United States Department of the Interior

FISH AND WILDLIFE SERVICE
Washington, D.C. 20240

Re: Draft Expanded Range Assessment and Phase II Site Inspection Work Plan, Former Vieques Naval Training Range (VNTR) Vieques

Photo 1. Eastern Conservation Area circa 1970. Note ground scarring and road cuts throughout the area.

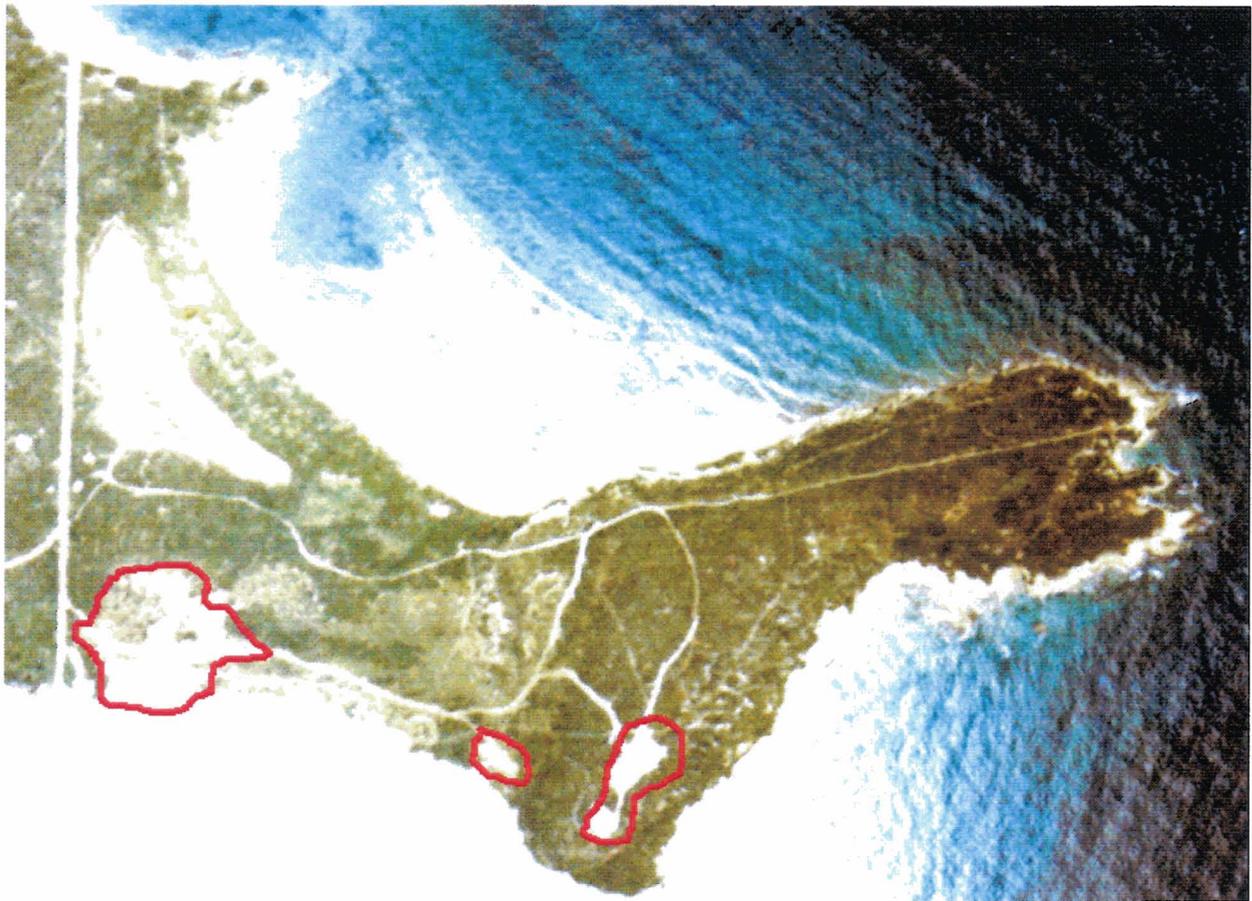
The Eastern Conservation Area (ECA) has been added to the existing TCRA as a MRA. It was established in the early 1980's as a conservation zone because of its unique ecology. However, aerial photos show extensive ground scarring and trails along the southern portion (Photos 1 and 2) that should be targeted for investigation. This area is botanically unique and vegetation removal should be minimized. Site selection and Work Plans for this area should be closely coordinated with the FWS. The existing trail system in this area should be included since it will be used by FWS personnel to access the different sites. We would also like to request that Dr. Gary Breckon be allowed to accompany the flora/fauna survey team into the ECA. Dr. Breckon has been contracted by the FWS to update the flora checklist for Vieques and he has already added several new species to the island botanical inventory. Given the uniqueness of this area, we believe that his participation in the survey would be a benefit to both the Navy and the FWS.

Photo 2. Eastern Conservation Area circa 2000. Note there are still some ground scars, but the majority of the area has some vegetative cover.

Photo 3. Puerto Ferro circa 1959. Note the location and extent of PI-9 (MRS 12). The fill area east of PI-9 in the bay was first noted at this time. Also note road heading southwest from this site.

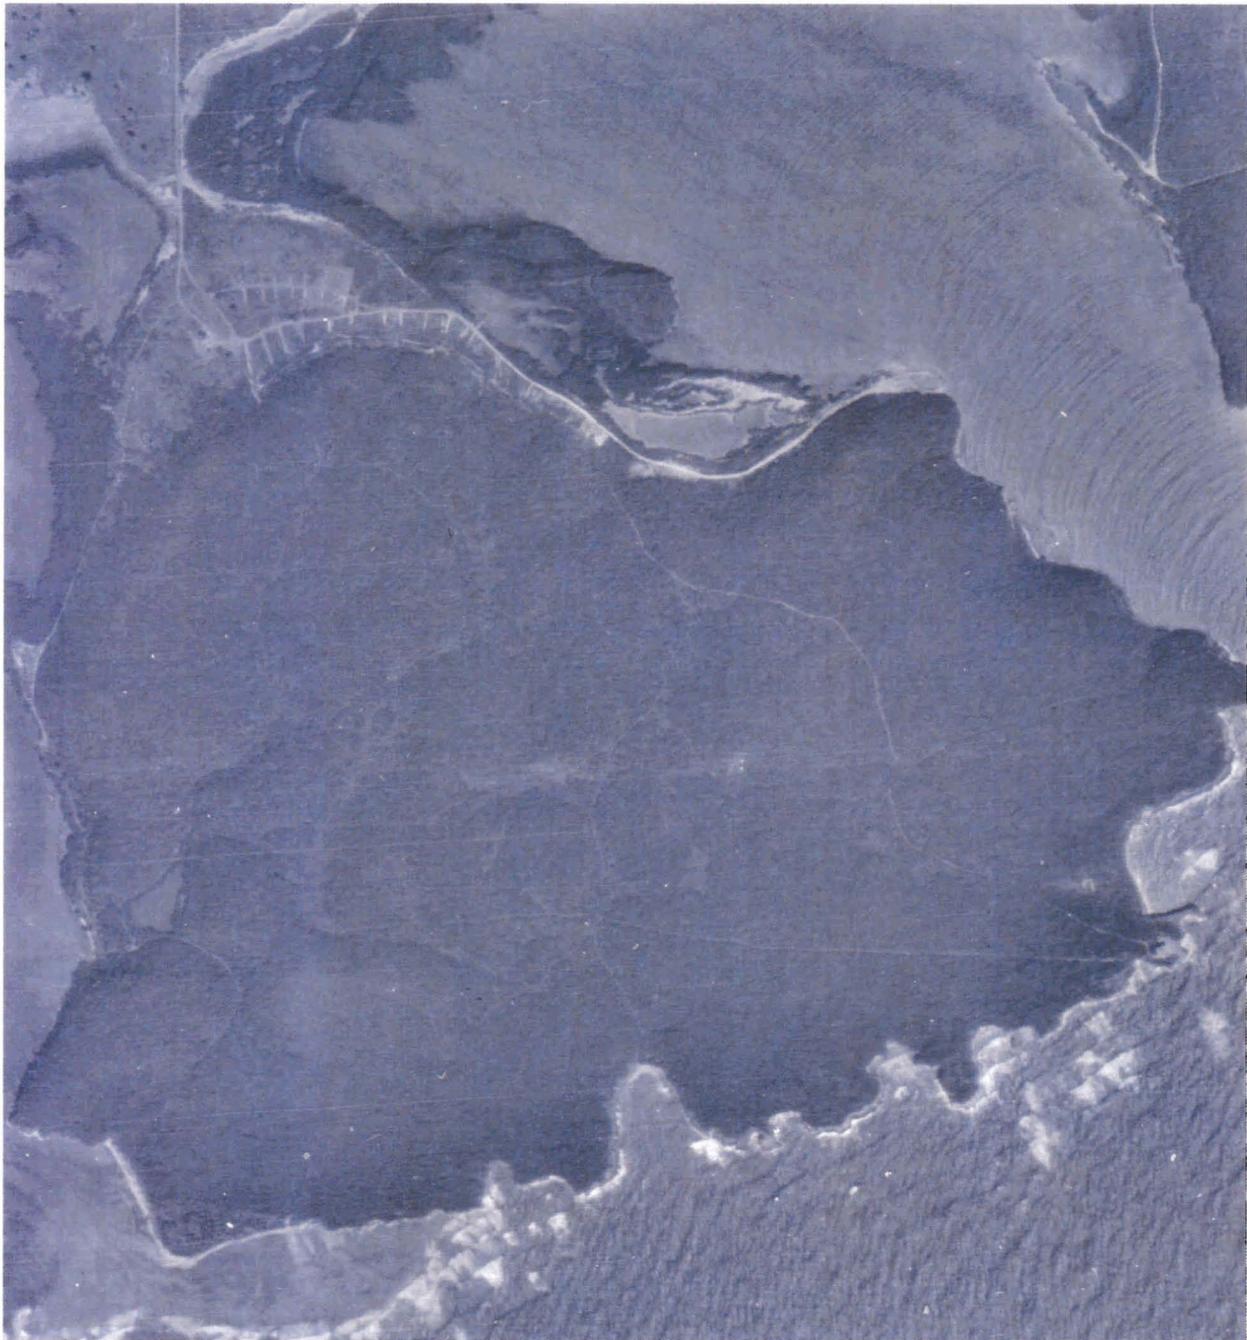
The Puerto Ferro Peninsula area has several MRSs and possibly some additional areas that warrant investigation. This is also the only area within the open section of Camp Garcia that is closed to the public. With its close proximity to open areas and the location of the historic Berdiales Lighthouse, opening this peninsula to public use is a priority for the FWS and the Municipality of Vieques. This area is currently composed of PI (Photo Identified area)-9 (MRS 12), PI-13 (MRS 14 or 46; in Table 3-1 it is cited as MRS 14, but in Figure 3-1 it is shown as MRS 46), the near shore munitions reef, several small trash piles containing shell casings, a small arms dump site and two large pits along a trail (Photos 3 through 8 and Figure 1). Photo Identified area 9 was clearly visible in historic aerial photos of the area (Photos 3 through 5) and is identified as a munitions or explosive storage area. At that time, a dirt road ran south along the west side of the peninsula, and two pits about 6-feet across and 3-feet deep are found on either side of this road, near a small inland lagoon (Figure 1). The origin of these pits is unknown, but there are sizable trees growing near them indicating that the area has not been disturbed in recent years. Another site associated with PI-9 is a fill area first identified in 1959 at the edge of Puerto Ferro and likely associated with an explosive storage area to the west. The deposit of shell casings associated with this site (Photos 6 and 7) are noted as increasing in size in 1962. In the 1970 aerial photos, the current access road to the lighthouse appears along with a large degree of ground disturbance. This is when PI-13 first appears along with the areas that now contain several trash piles (Photo 8). The FWS requests that during the Phase II Site Investigation (SI), all of the sites in the Puerto Ferro Peninsula be investigated.

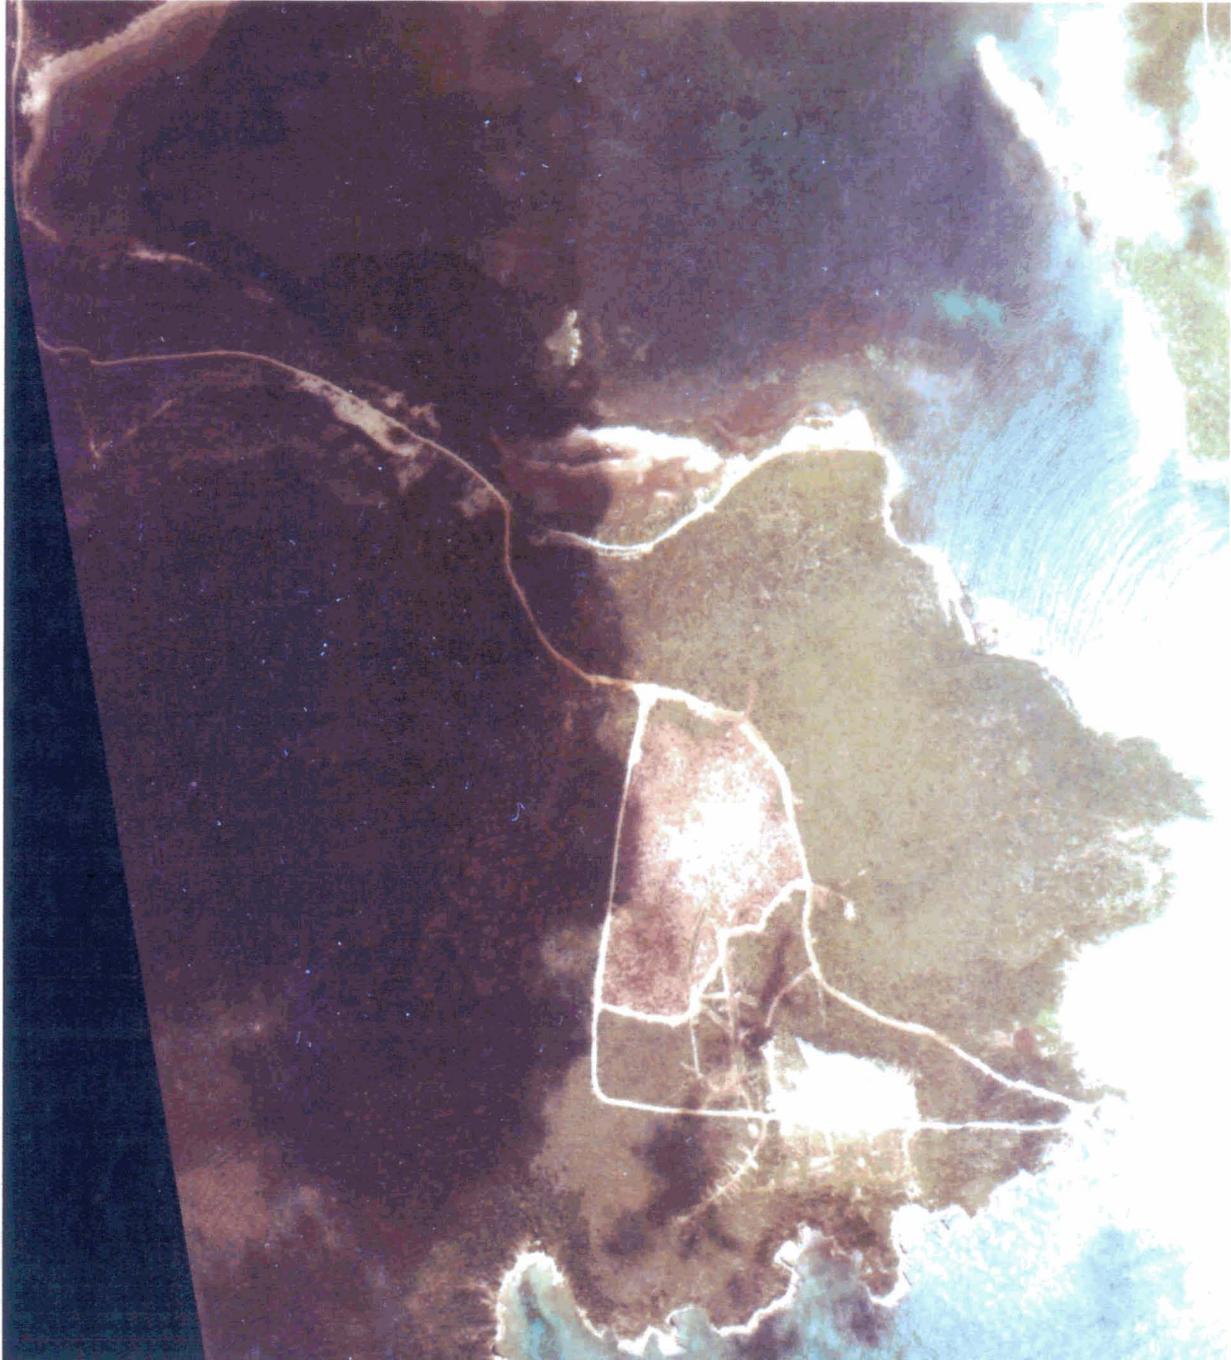
Photo 4. Puerto Ferro circa 1970. Note the decrease in size of PI-9, however this photo marks the appearance of PI-13 (MRS14 or 46), scarred areas near the lighthouse, the creation of the existing lighthouse road, the burn area in the central portion of the photo, and additional roads. With the exception of the lighthouse road, many of these sites are now covered with sparse vegetation.

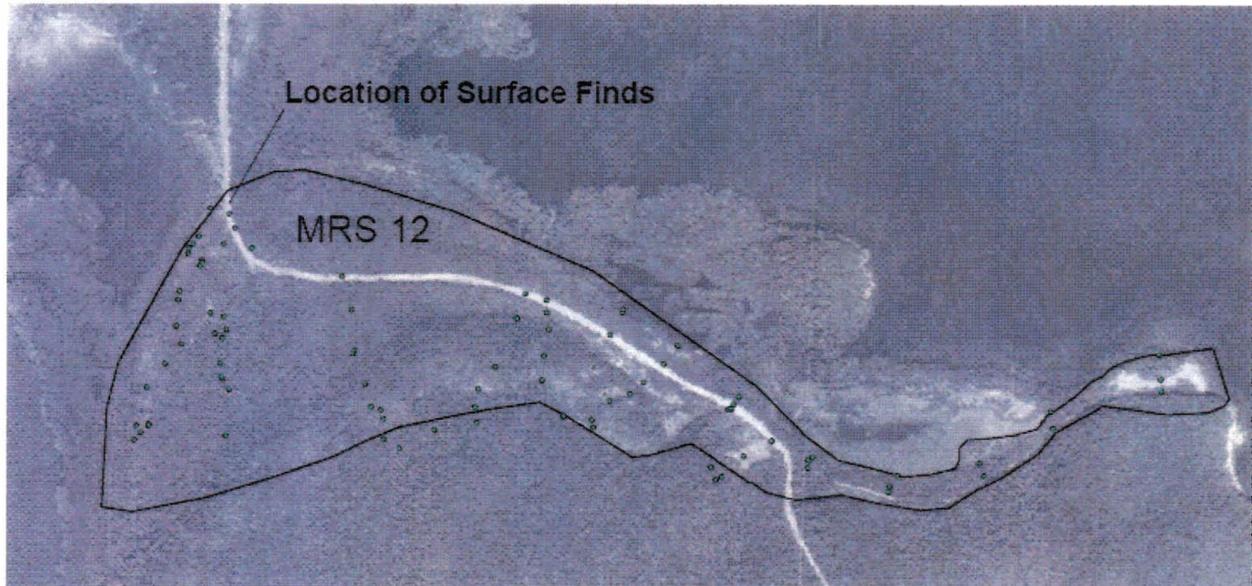
Photo 5. Expanded Range Assessment Site Investigation Phase I subsurface anomalies. Note that many of the hits were in the location of the old ammunition or explosive storage areas. Two expended 155 mm and 120 mm projectiles were found near the access road where several buildings once stood. While no anomalies were found north of the road, aerial photos indicate that structures were present north of the road where it curves to the east.

Photo 6. Shell casings found in very shallow water several yards from the current shoreline of the fill area along the eastern shore of PI-9. The fill area may have extended beyond this point and the fill may have eroded and exposed the casings. This particular area is usually shown to demonstrate “contamination” that has been caused by historic Department of Defense activity at Vieques.

Photo 7. Deposit of small arms ammunition in salt flat north of PI-9. The extent of this dump is not known.

Photo 8. One of several trash dumps located along the old lighthouse road in Puerto Ferro containing munitions debris. The extent of these dumps is not known.
